STATE OF MAINE
DEPARTMENT OF TRANSPORTATION
16 STATE HOUSE STATION
AUGUSTA, MAINE 04333-0016

January 5, 2018
Subject: Barrel Bridge Replacement
State WIN: 018957.00
Location: **York**
Amendment No. 1

Please make the following changes to the Bid Documents:

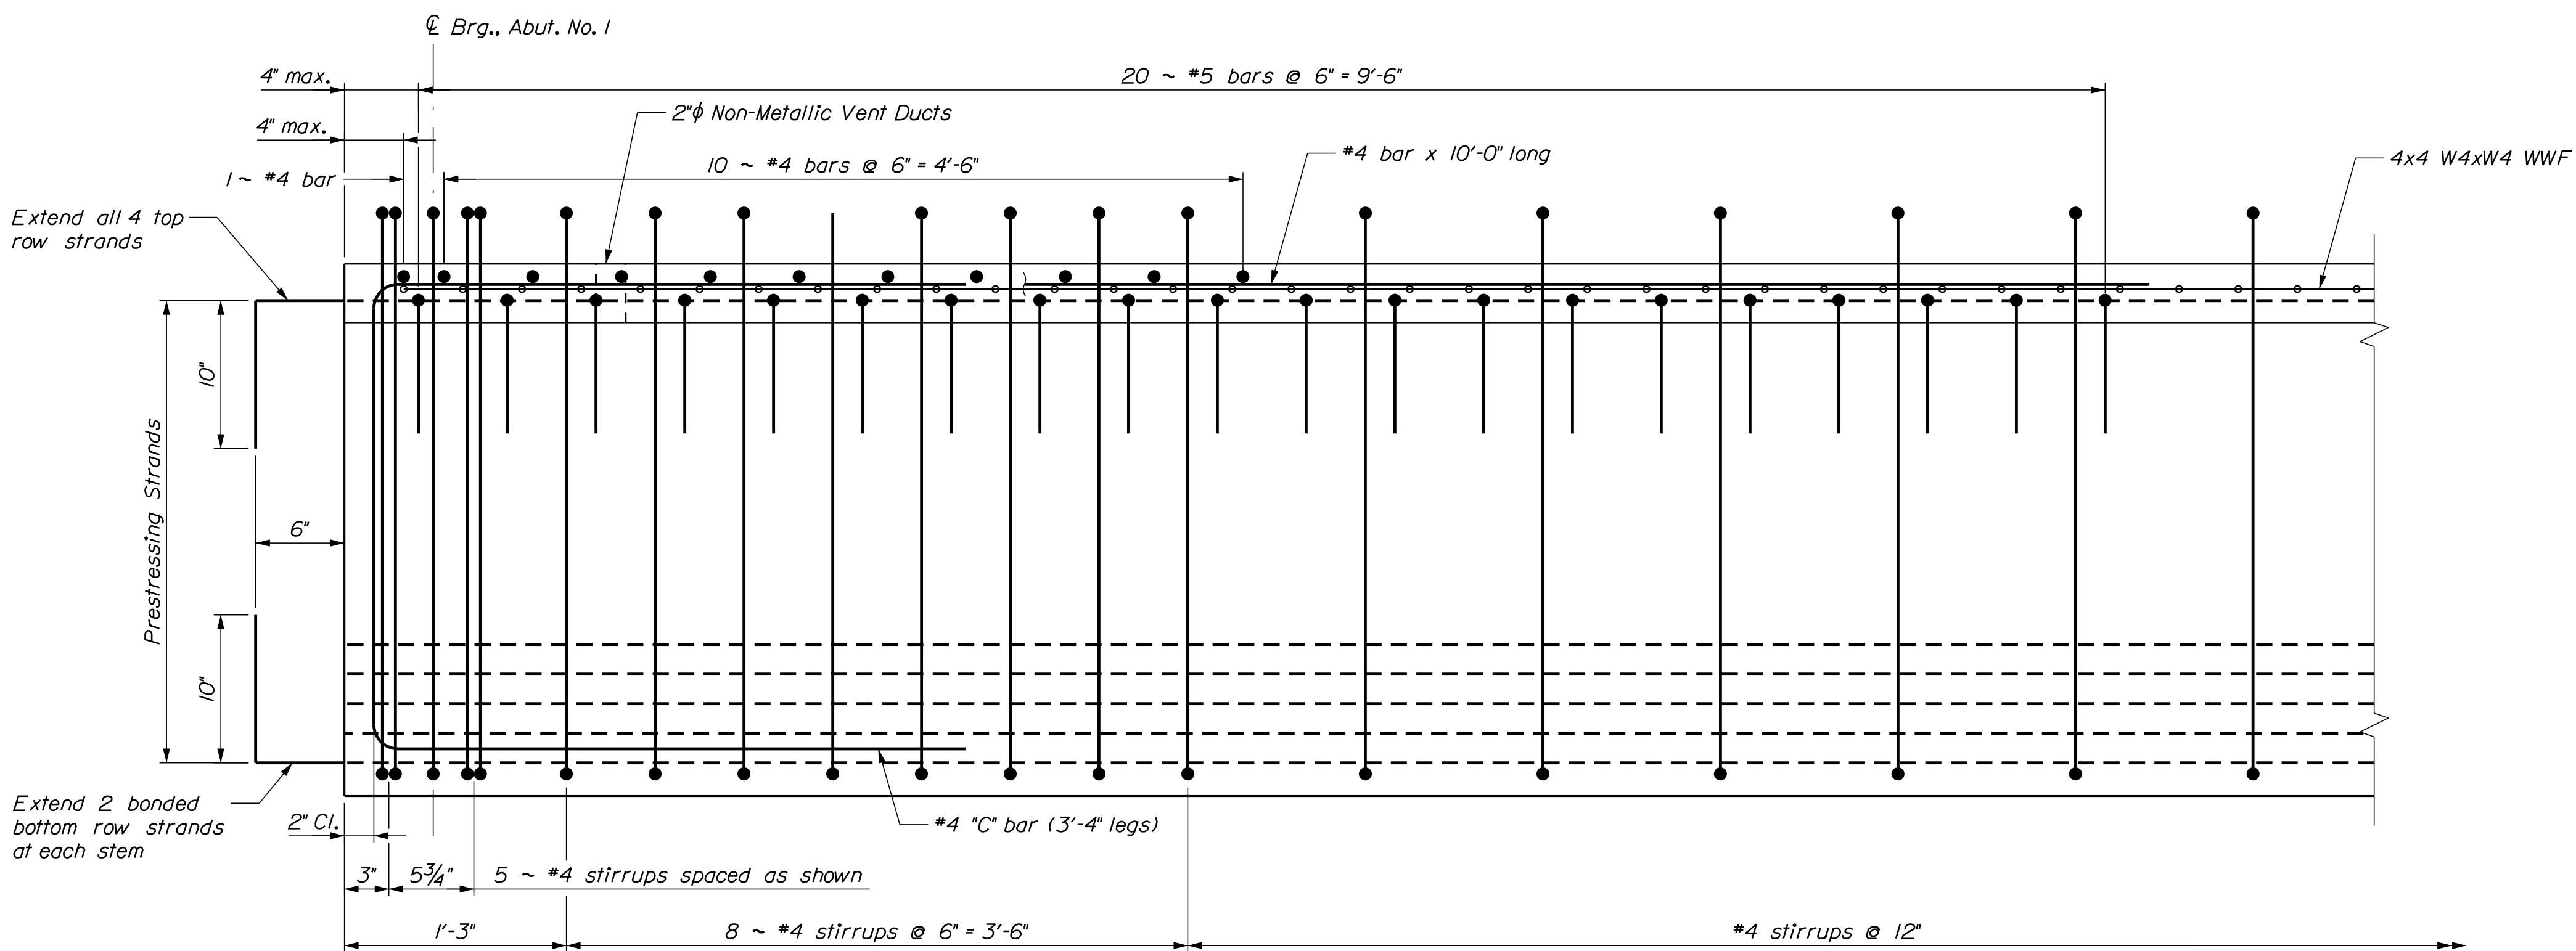
REMOVE SHEET NUMBER 24 OF 31, NEXT BEAM DETAILS I, and **REPLACE** with the attached, revised SHEET NUMBER 24 OF 31, NEXT BEAM DETAILS I.

Question: On Sheet 24 of 31 there is a note indicating that there are #4 bars not shown in the stems of the NEXT beams. Can you confirm how many bars will be in each stem as there does not seem to be any detail showing a quantity of these bars?

Response: There are no additional #4 bars in the NEXT beam stems, please see revised sheet 24 for clarification. The NEXT beam reinforcement as shown in the details on sheet 25, is correct.

BARRELL BRIDGE
DOLLY GORDON BROOK
YORK COUNTY
YORK
END DIAPHRAGM
REINFORCING

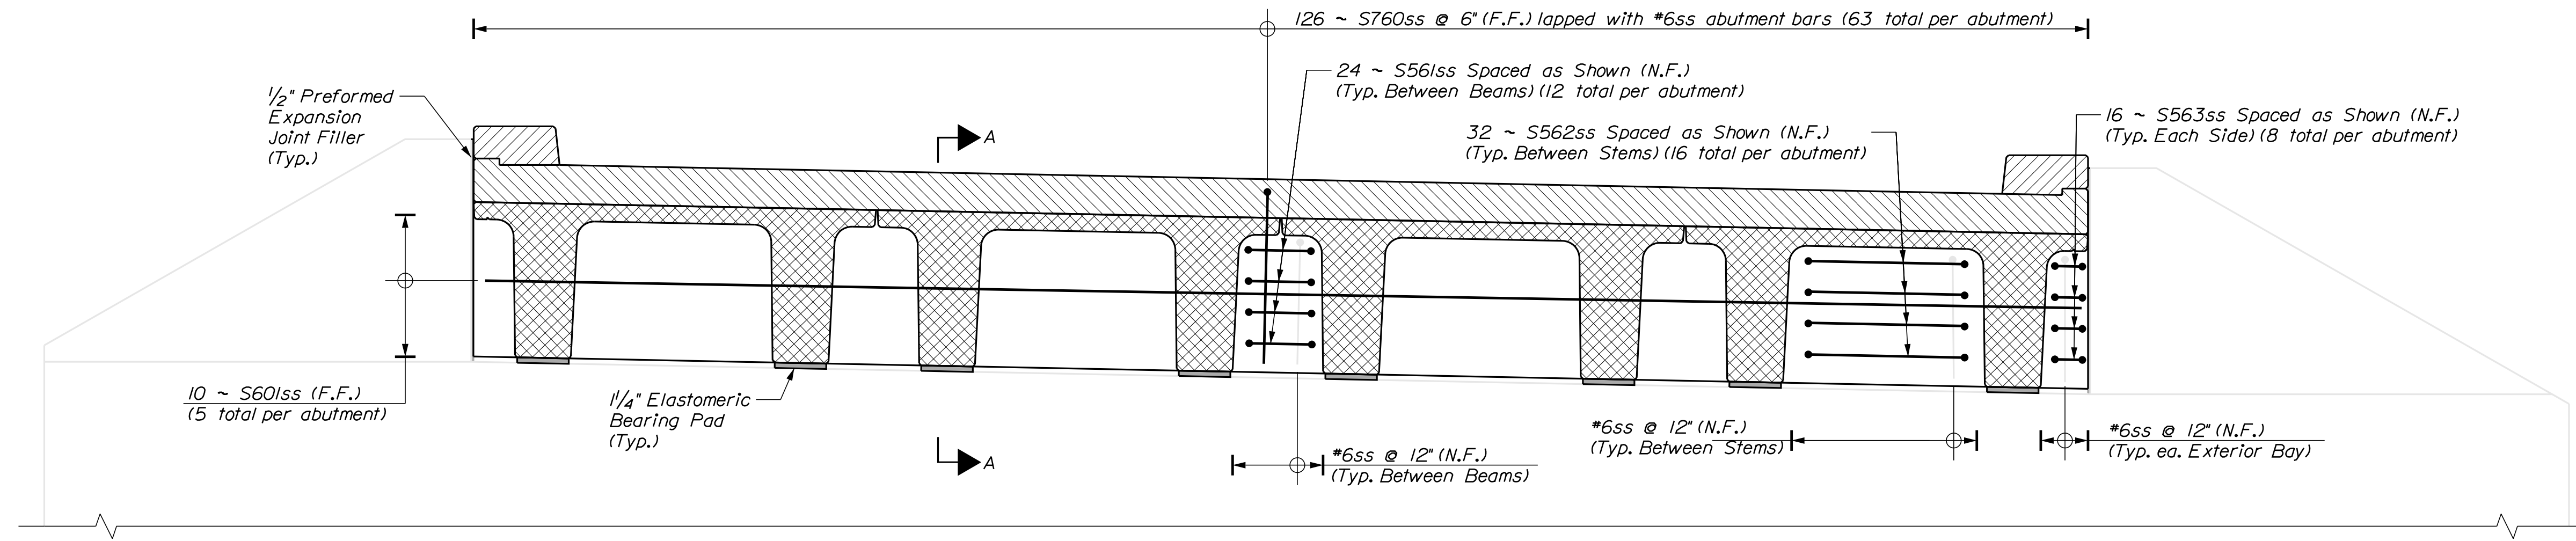
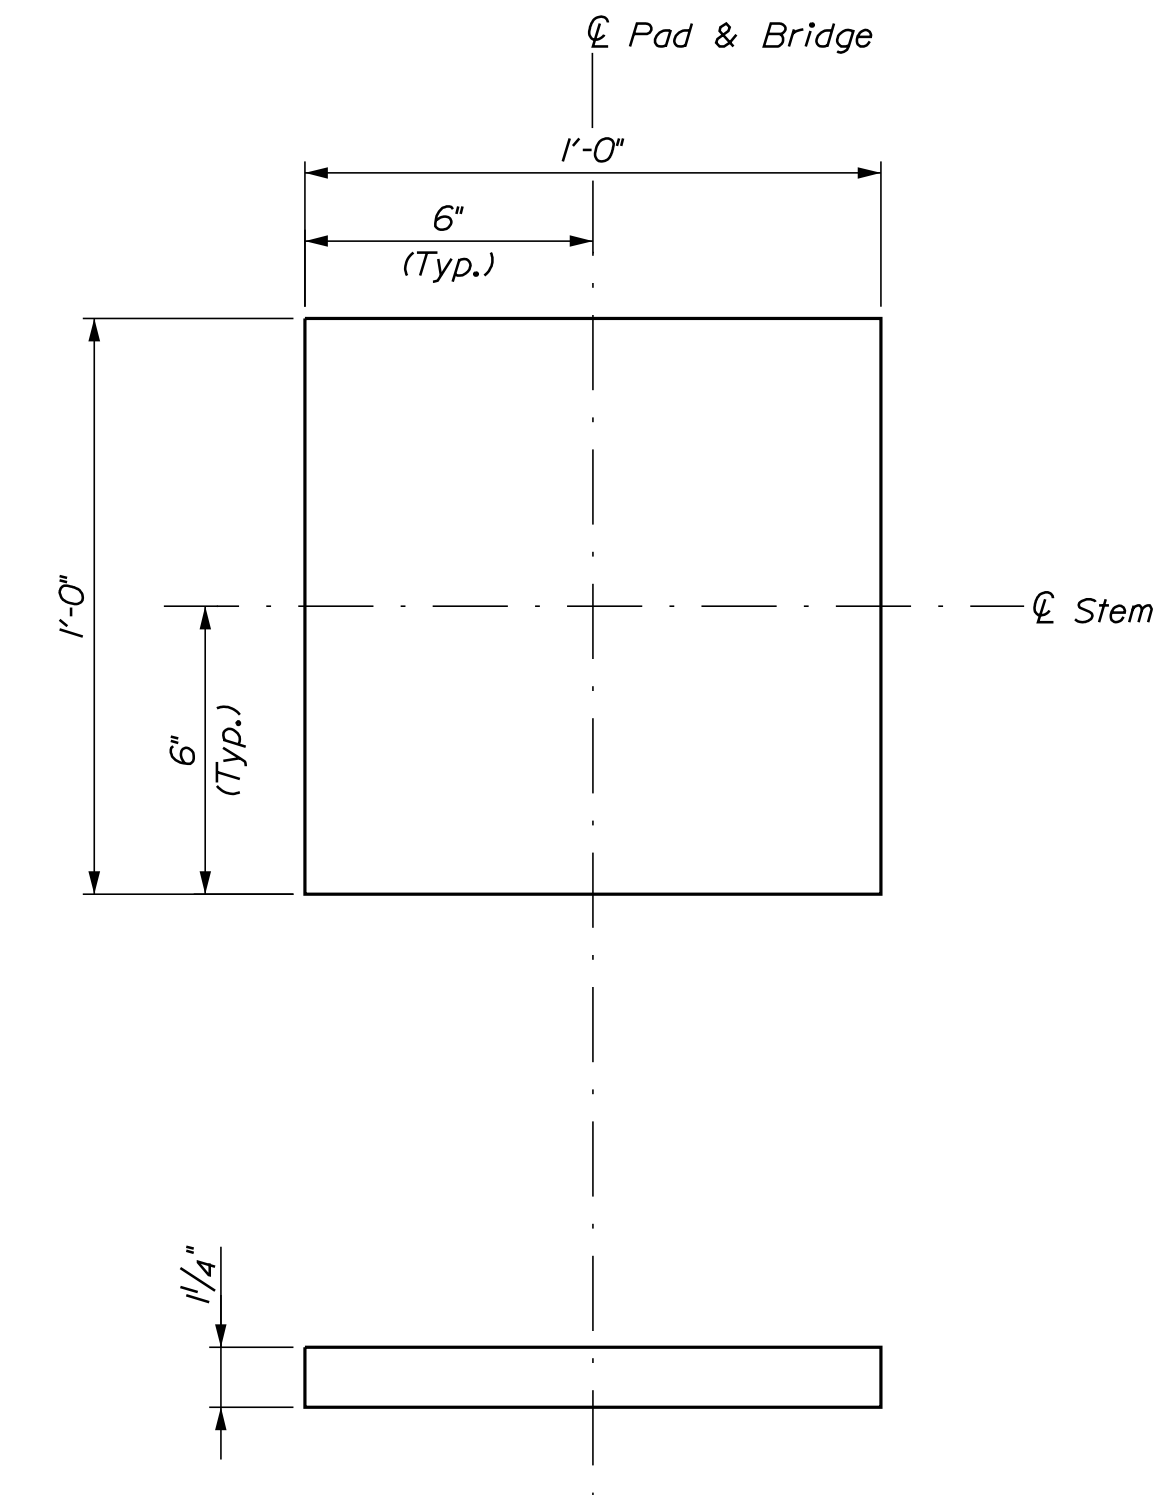
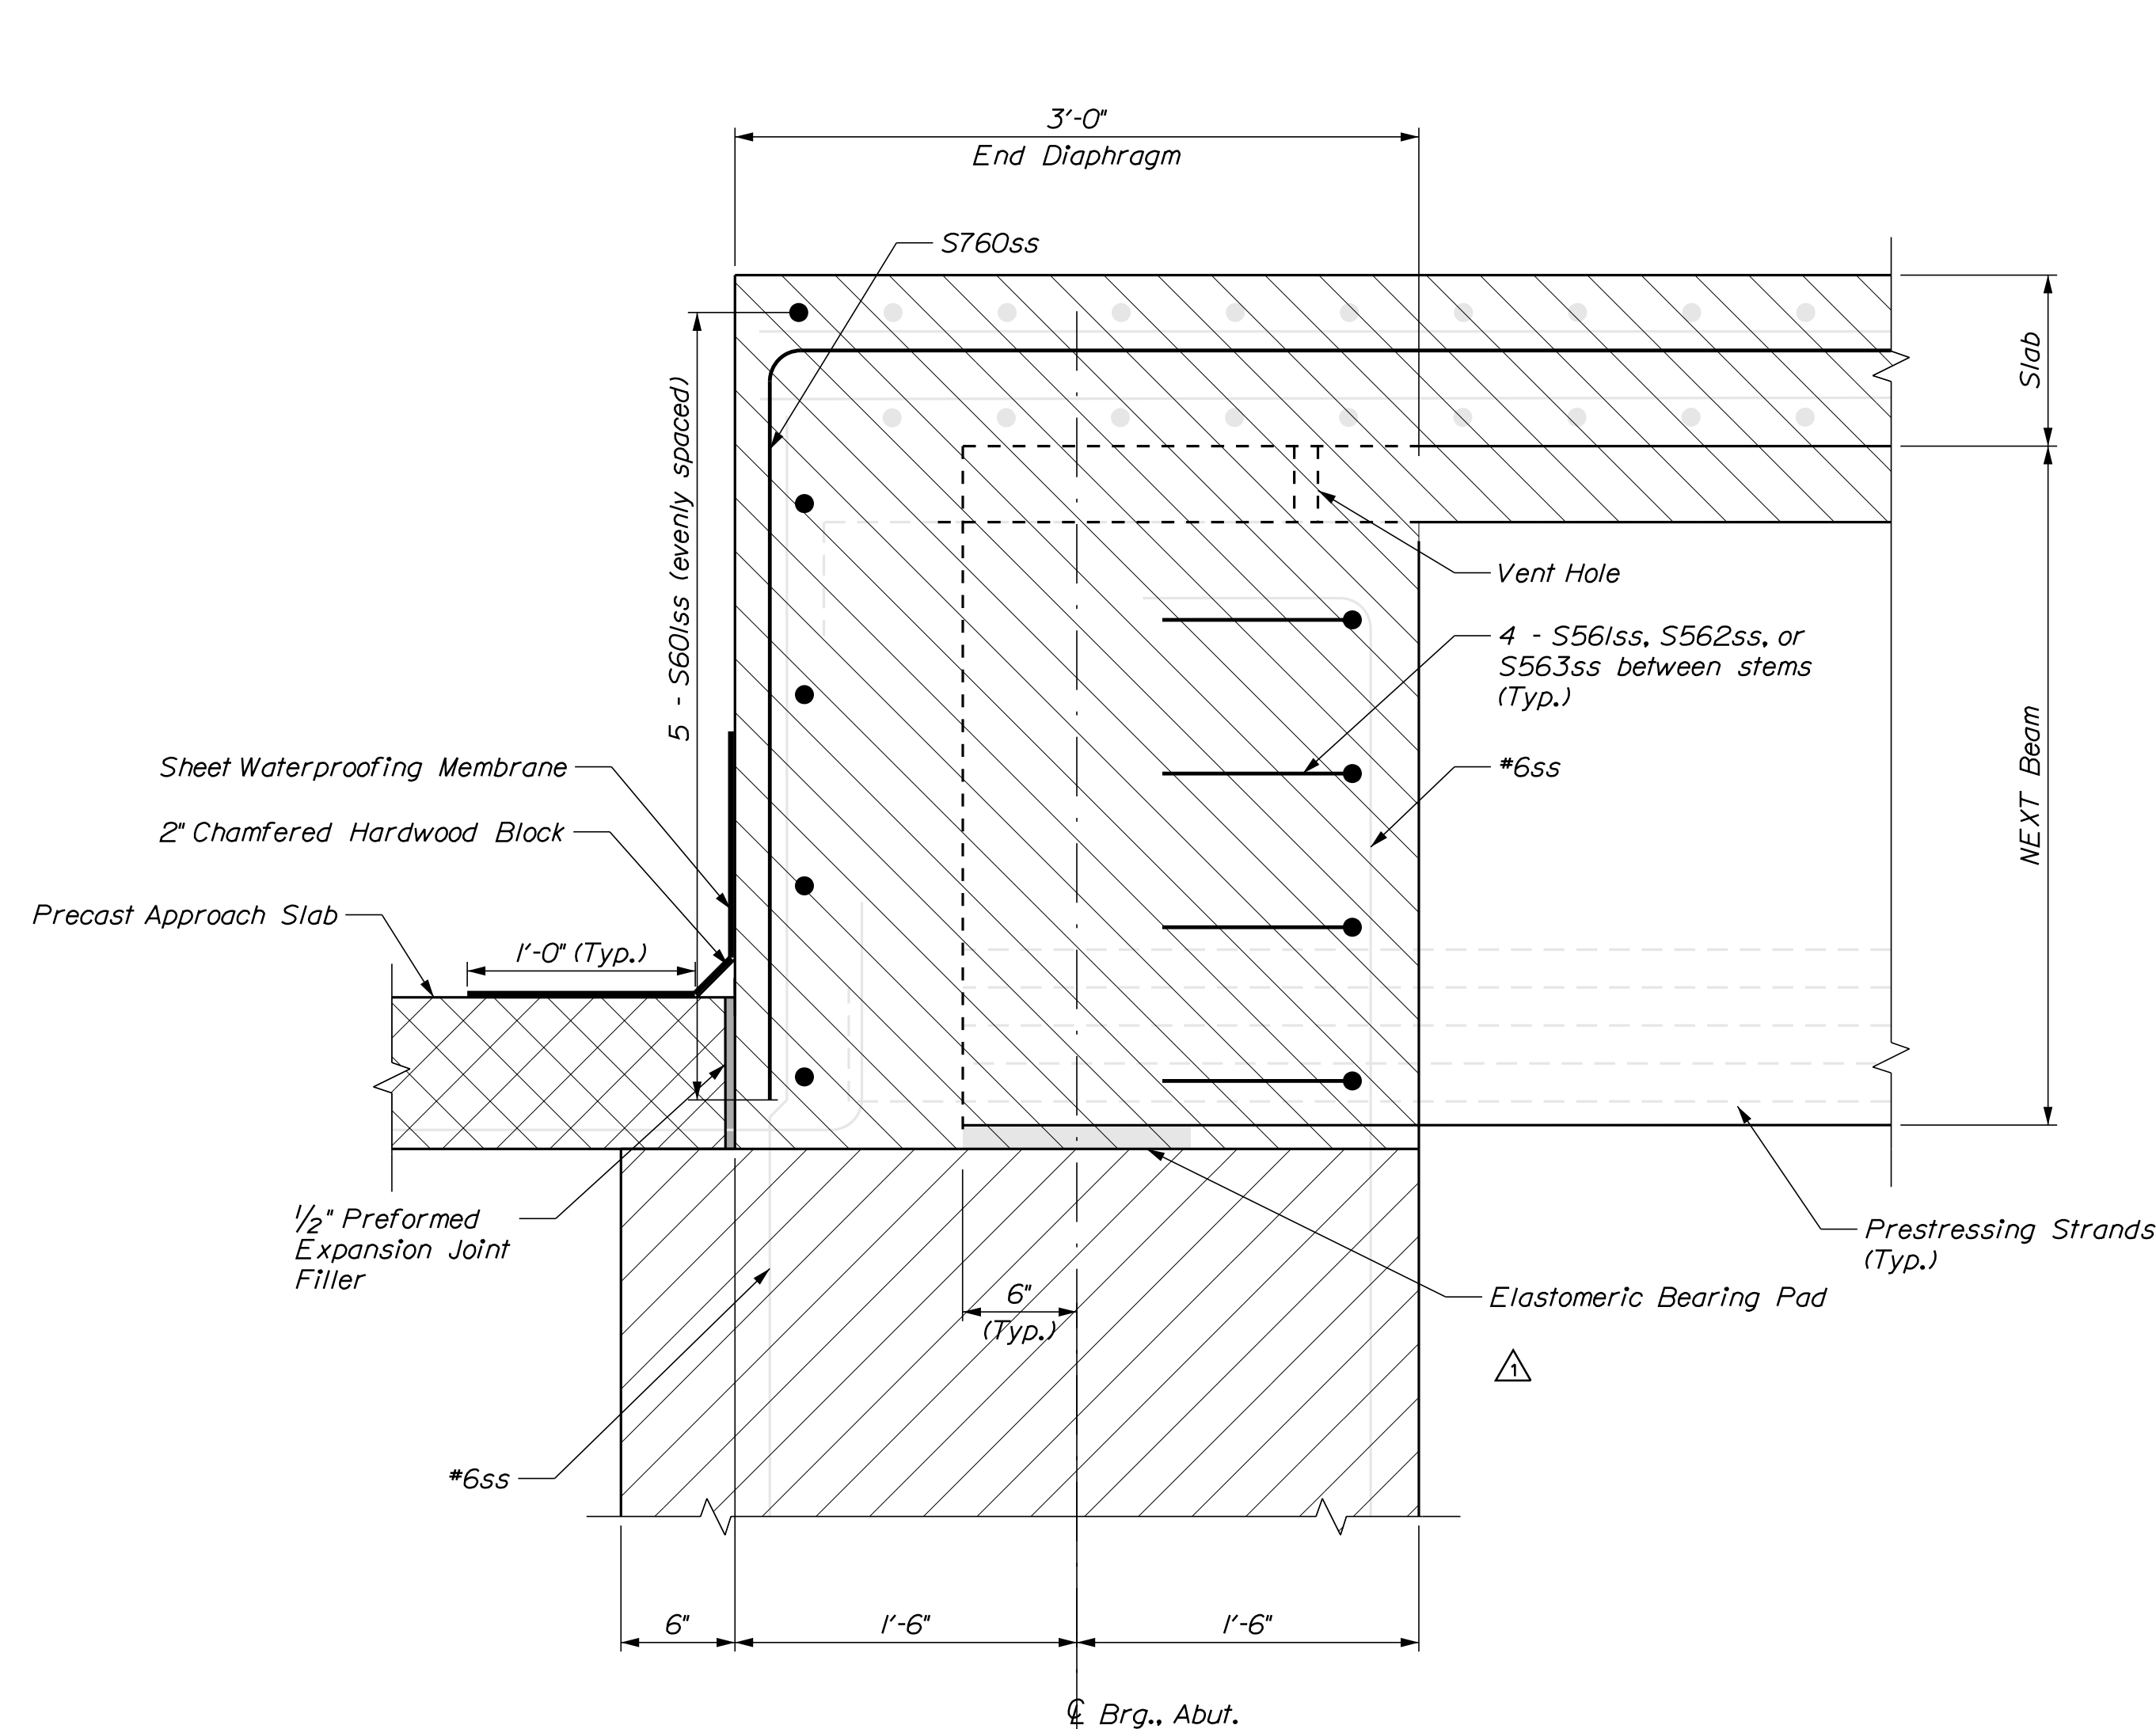
REMOVE SHEET NUMBER 28 OF 31, END DIAPHRAGM REINFORCING, and **REPLACE** with the attached, revised SHEET NUMBER 28 OF 31, END DIAPHRAGM REINFORCING.

Question: What is the overall length of the NEXT beams? Can't find a dimension past Center Line of bearing.

Response: The NEXT beams shall have a 6" extension past the center line of bearing of the bridge at both abutments, resulting in an overall length of 76'-0". Please see revised plan sheet 28 for clarification.
